ARIZONA DEPARTMENT OF ENVIRONMENTAL QUALITY

April 2, 2020
FPU20-228

RE: WAFB – ADEQ Comments – *Draft, Soil Vapor Extraction System And Pilot Study, 2018 Annual Performance Report, Former Liquid Fuels Storage Area, Site ST012, Former Williams Air Force Base, Mesa, Arizona*; prepared for Air Force Civil Engineer Center [AFCEC/CIBW], Lackland AFB, TX; prepared by Amec [Foster Wheeler] Environment & Infrastructure, Inc. (Amec), Phoenix, AZ; document dated December 17, 2019.

Comment Figure 1

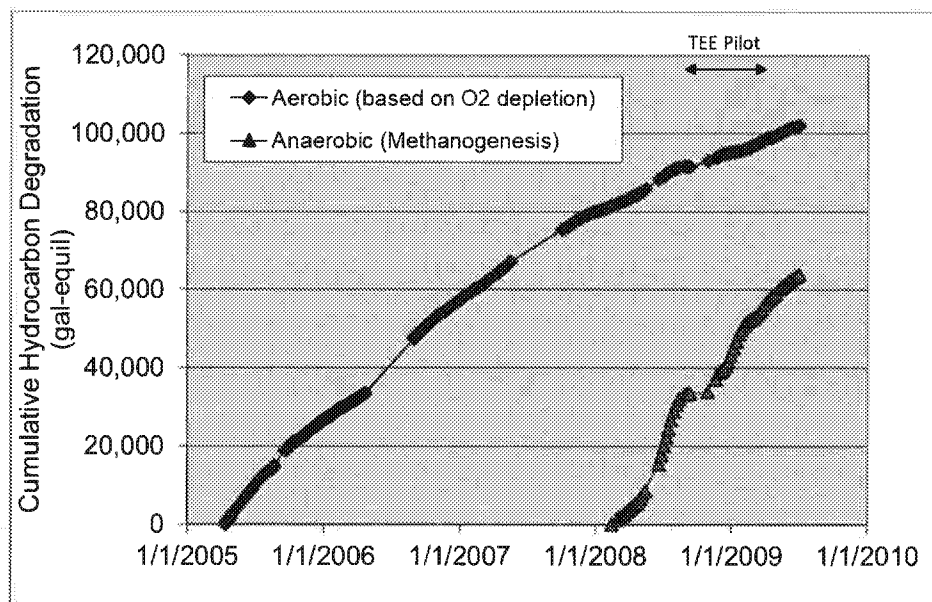
- 20 Page 2-31, Section 2.3.1 *Mass Removal and Destruction Efficiency*, line 772-774 [*Also please refer to the illustrative figure following this comment.*]. The text states that prior to SEE, CH₄ concentrations in the vapor collected by SVE were much lower and that the collection of CH₄ by SVE appears related to SEE and suggests that the CH₄ is likely generated in the saturated zones. However, methane was monitored in the SVE manifold from early 2008 through at least mid-2009 and similar rates were observed at that time as indicated in the graph below (Comment Figure 1) from an historical ST012 SVE progress report. Consider editing the text to state that anaerobic degradation has been observed throughout the SVE operations; however, delineating the locations of degradation between the saturated zone and the vadose zone is difficult. In addition, increased temperature within limits is known to increase anaerobic degradation rates such that the TEE and SEE efforts both impacted the rates but quantification of the impact is not possible with the available data.

Comment Figure 2

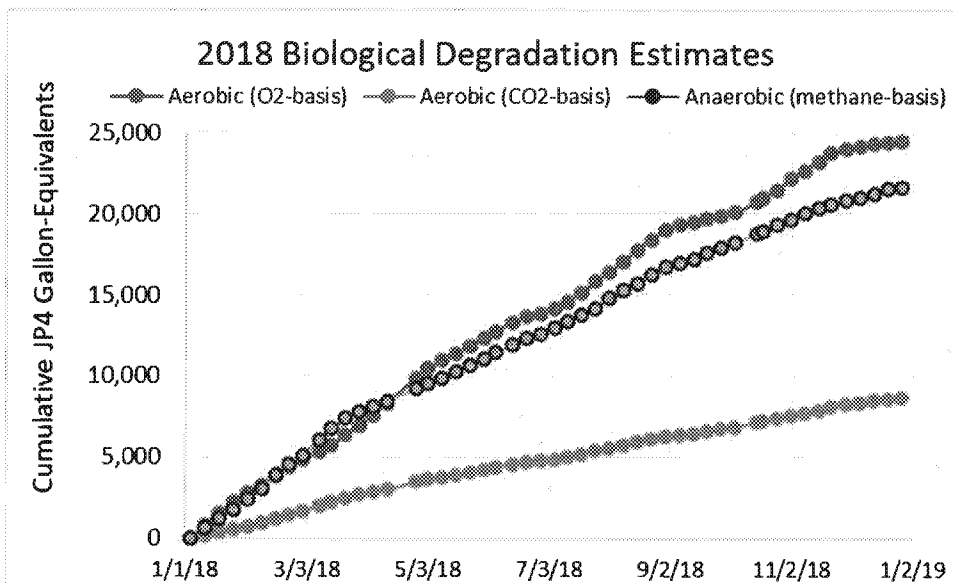
- 29 Page 2-33, Section 2.3.2 *Notable Trends*, line 858. Should the sentence refer to increases in CO₂ rather than CO?
- 30 Page 2-33, Section 2.3.2 *Notable Trends*, line 863 [*Also please refer to the illustrative figure following this comment.*]. Please provide some discussion on the estimated magnitude of aerobic degradation occurring based on oxygen depletion and carbon dioxide production. For example, using field measures at the wellfield influent for flow rate, oxygen content, and carbon dioxide content (provided in Appendix B), the rate of hydrocarbon degradation averaged 450 pounds per day based on oxygen depletion and 160 pounds per day based on carbon dioxide production. Using these rates, the estimated volume of fuel hydrocarbons degraded by aerobic processes reported in the 2018 period ranges from 8,700 to 24,500 gallon-equivalents. Similar calculations for methane yield a 2018 total anaerobic degradation of 21,600 gallon-equivalents as illustrated below (Comment Figure 2). The anaerobic estimate appears to be higher than the value suggested by Graph 2-2 of the Annual Report (Page 2-31).
